Committee of Experts on the Transport of Dangerous Goods and on the Globally Harmonized System of Classification and Labelling of Chemicals

Sub-Committee of Experts on the Transport of Dangerous Goods

Explosives and related matters: tests and criteria for flash compositions

Comments on the apparatus, materials and criteria of US- and HSL Flash Composition Tests

Fig. 1 Influence of a gap between the witness plate surface and the bottom end of sample filled in the sample tube on indentation depth

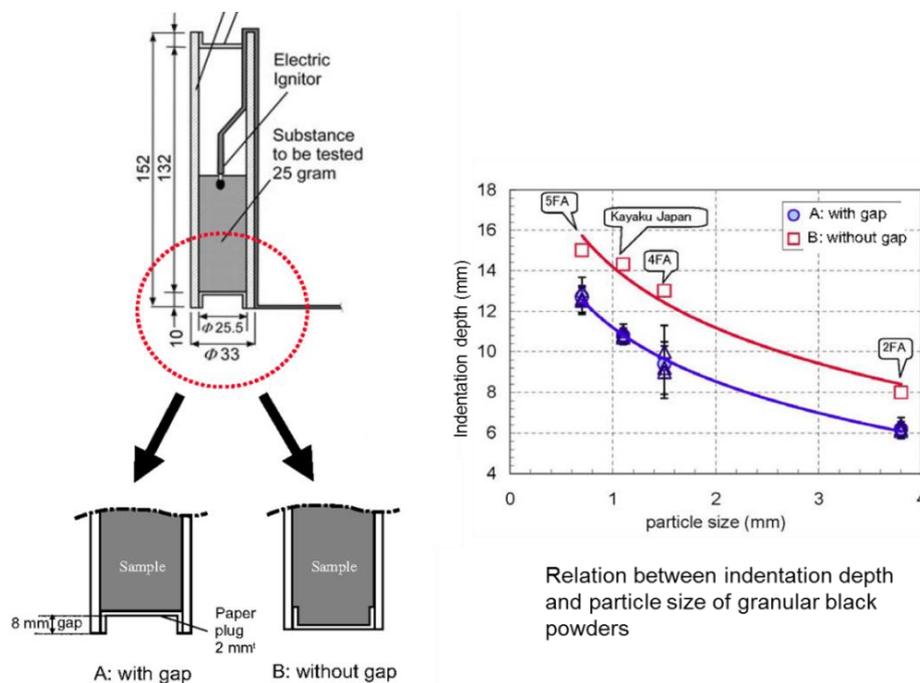
8. Figure 1 demonstrated considerable effect of an air gap between the witness plate surface and the bottom end of sample filled in the sample tube on the indentation depth. It was shown that air gap 8 mm in thickness could decrease indentation depth by 2 - 3 mm. Expert from Japan invites TDG to consider adding appropriate wording to avoid making unnecessary air gap in "Procedure" description of US Flush Composition Test.

- Appropriate wording to avoid making unnecessary air gap should be added in “Procedure” description of US Flush Composition Test.
- To avoid experimental failure due to unexpected bursting of aluminium disc below 2070 kPa, recommended thickness of aluminium bursting disc described in APPENDIX 7 of Manual of Tests and Criteria should be changed from 0.2 mm to 0.4 mm.

Fig. 2 Comparison of Δt between current- and modified HSL tests for very same samples

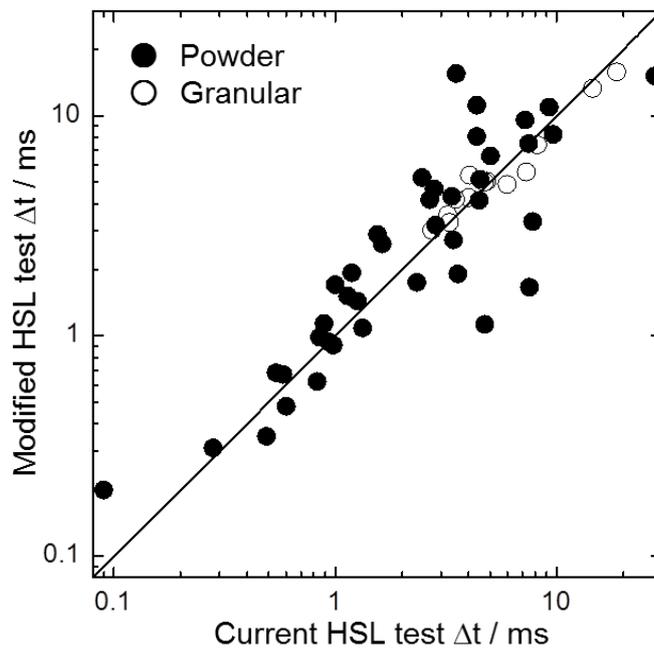
11. Figure 2 showed the comparison of Δt measured by current- and modified HSL test for very same samples. Although data points showed significant scattering, that was possibly caused by poor reproducibility of burning rate of each sample, the distribution of scattered data showed no noticeable bias between two different electrode structures. High-speed video observation looking at the feed ports of the electrodes was also conducted for both structures but no visible gas leaking was observed. Thus, the difference in the gas leaking rate, if any, seemed to be so small that no noticeable difference appeared in terms of test performance between current- and modified HSL tests apparatus.

- The modification of HSL test apparatus is not indispensable although the simplified electrode structure of the modified HSL test apparatus was preferable.

Fig. 3 Typical alignment of igniter at the upper side of the ignition plug of current HSL test apparatus

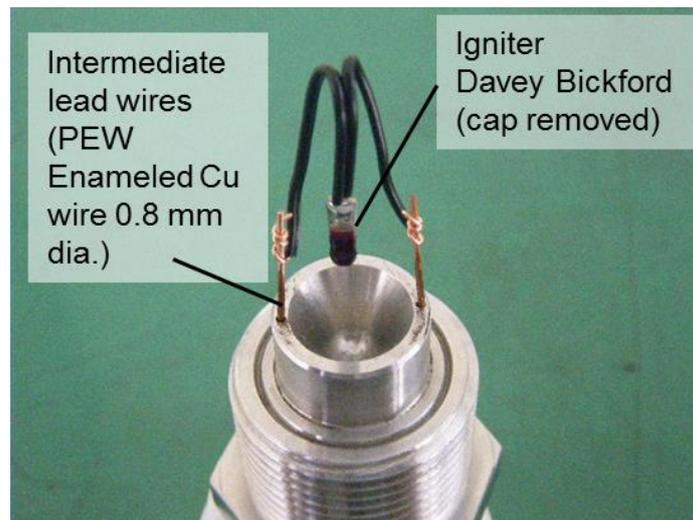
12. Figure 3 shows typical alignment of igniter at the upper side of the ignition plug of current HSL test apparatus. In this work, lead wires of igniter were not connected directly to electrodes that were screwed from the bottom of the plug, but connected to intermediate lead wires that were connected to the screwed electrodes. The metal body and insulating coat of the intermediate lead wires (PEW enamelled Cu wire 0.8 mm in diameter) were strong enough to withstand multiple experiments without being replaced. Thus, by using

the intermediate lead wires, procedures of igniter replacing in current HSL test could be significantly simplified.

13. According to the results mentioned above, the expert from Japan considered that the modification of HSL test apparatus was not indispensable although the simplified electrode structure of the modified HSL test apparatus was preferable.

Fig. 4 Plots of indentation depth as a function of corresponding Δt for various compositions

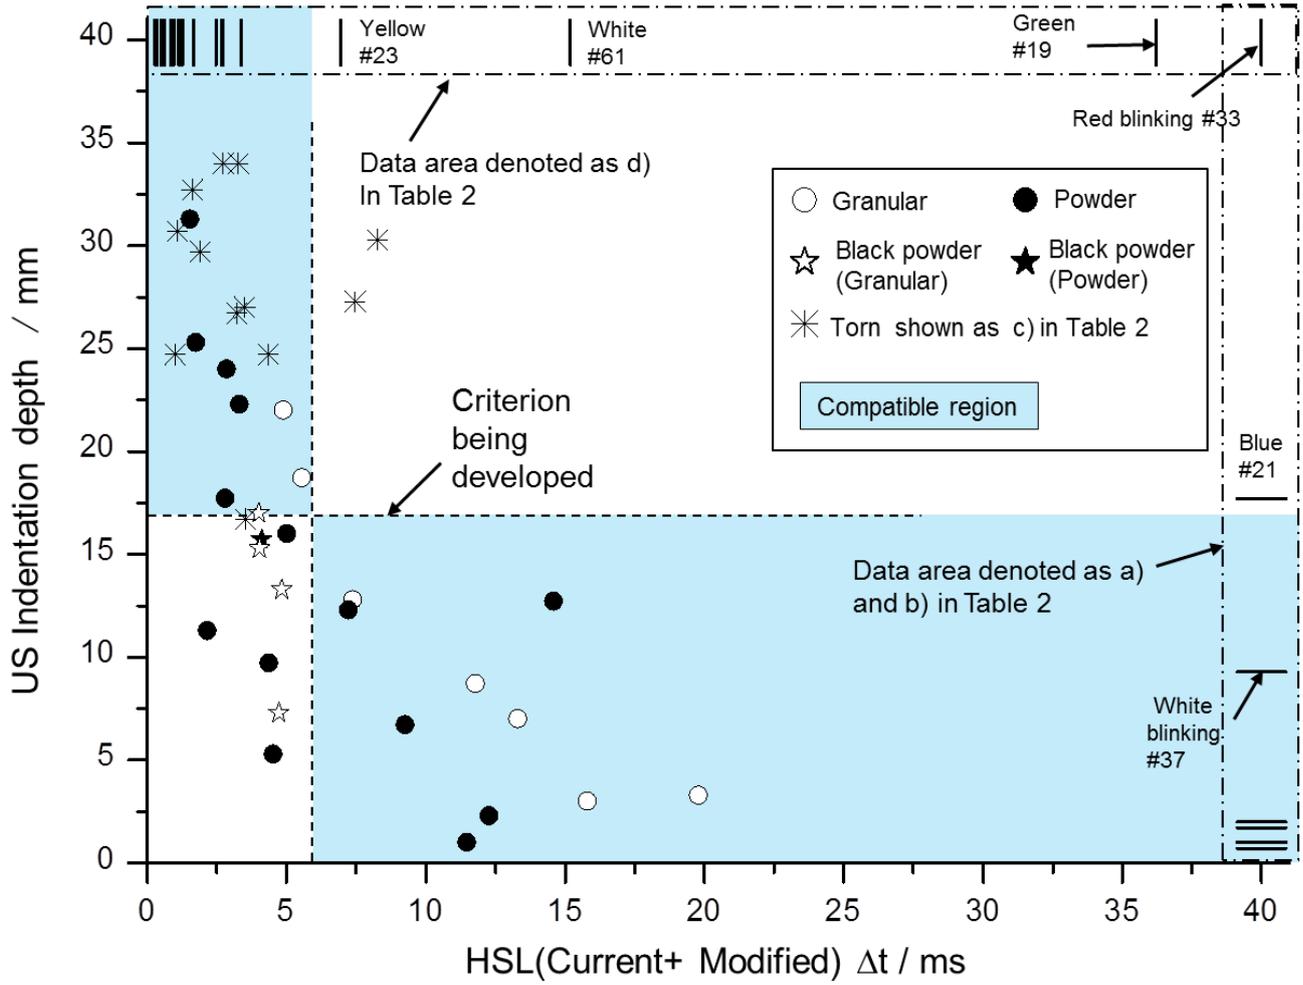
14. Table 2 showed all data of US-, HSL- and modified HSL tests for 69 kinds of firework compositions. From this table, all indentation depths were plotted in Fig. 4 as a function of corresponding Δt . Because current- and modified HSL tests were considered to be equivalent in this work, smaller value was selected as Δt among those obtained by current- and modified HSL tests. As for the US test, average value of indentation depth was defined including the case that at least one of the witness plates was slightly torn.

15. Distribution of the data plotted in Fig. 4 showed rough tendency that larger indentation depth corresponded to smaller Δt . However, there were some abnormal cases such as White #61, Green #19, Red blinking #33 and Blue #21 that did not apply to the tendency.

16. Figure 4 showed that the witness plate started to be torn at the indentation depth of about 17 mm. Therefore, the appropriate criterion of indentation depth could be set to 17 mm. This value was also acceptable in respect that the black powders could mostly be classified into non-flash composition.

17. However, it should be noted that this criterion was based on SPCC witness plate. In case that witness plates of ST37 or S235JR compatible were used, or there was no standardization for steel grade, the criterion of 15 mm based on ST37 or S235JR witness plate (see ST/SG/AC.10/C.3/2013/24) should be selected in order to stay on the safe side.

- The appropriate criteria of indentation depth based on SPCC witness plate could be set to 17 mm. This value was also acceptable in respect that the black powders could mostly be classified into non-flash composition.

- In case that SPCC could not be a standard grade of witness plate, the criterion of 15 mm should be selected in order to stay on the safe side.
- If there is a consensus that black powder can be regarded as a standard of non-flash composition, the criterion of HSL test can be changed to 4 ms.

Fig. 5 Compatibility mapping as functions of HSL test criterion: x and US test criterion: y

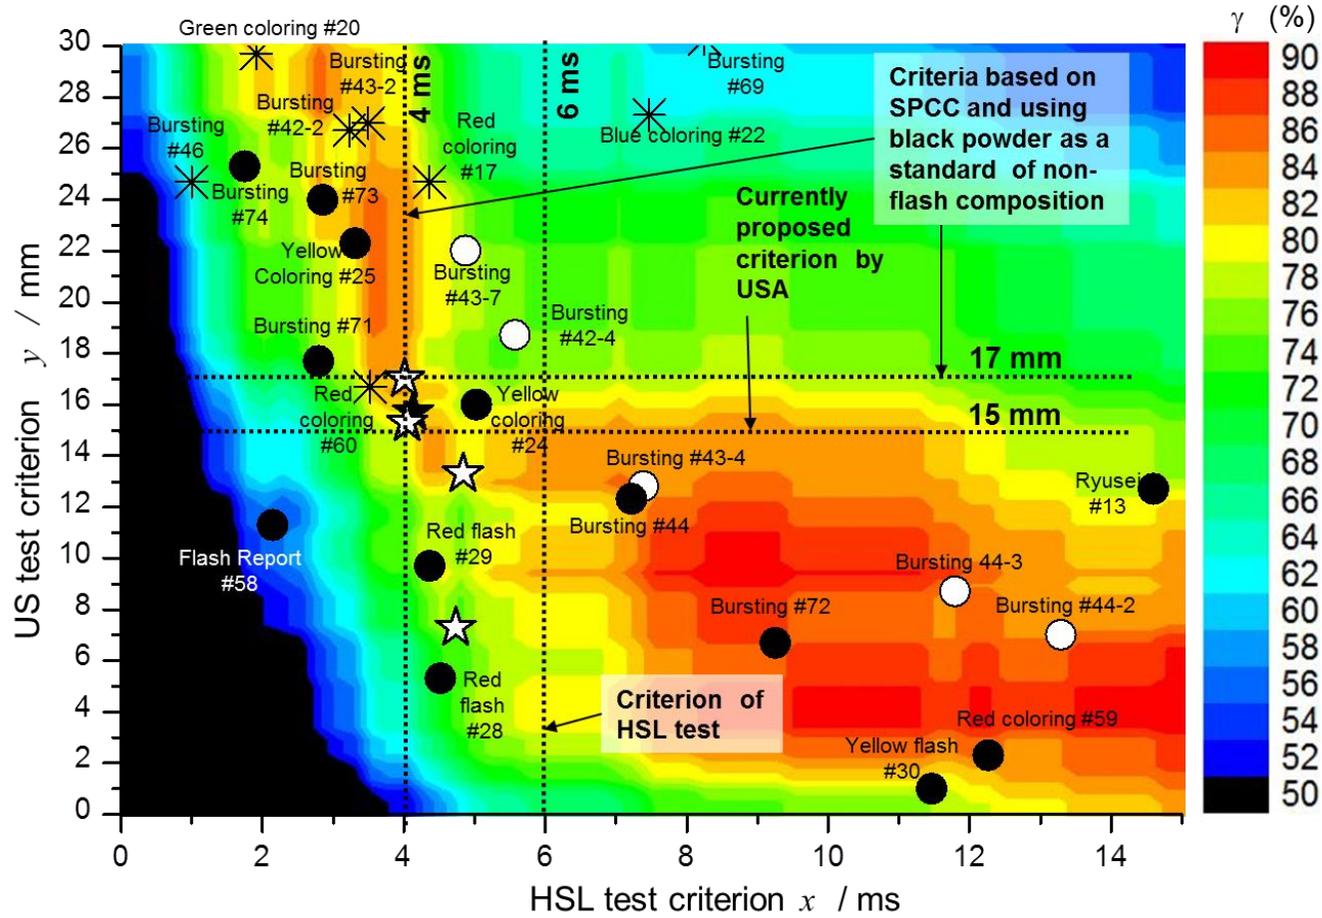
20. Figure 5 shows a mapping of compatibility: γ using all data of this work. Combination of $x = 4$ ms and $y = 17$ mm derived by the above discussions gave reasonable compatibility of about 84 %. Combination of currently adopted criterion $x = 6$ ms and $y = 15$ mm proposed by USA also gave reasonable compatibility of about 84 %. Other combinations, such as $x = 4$ ms and $y = 15$ mm or $x = 6$ ms and $y = 17$ mm gave slightly lower compatibilities of 78 – 80 %.
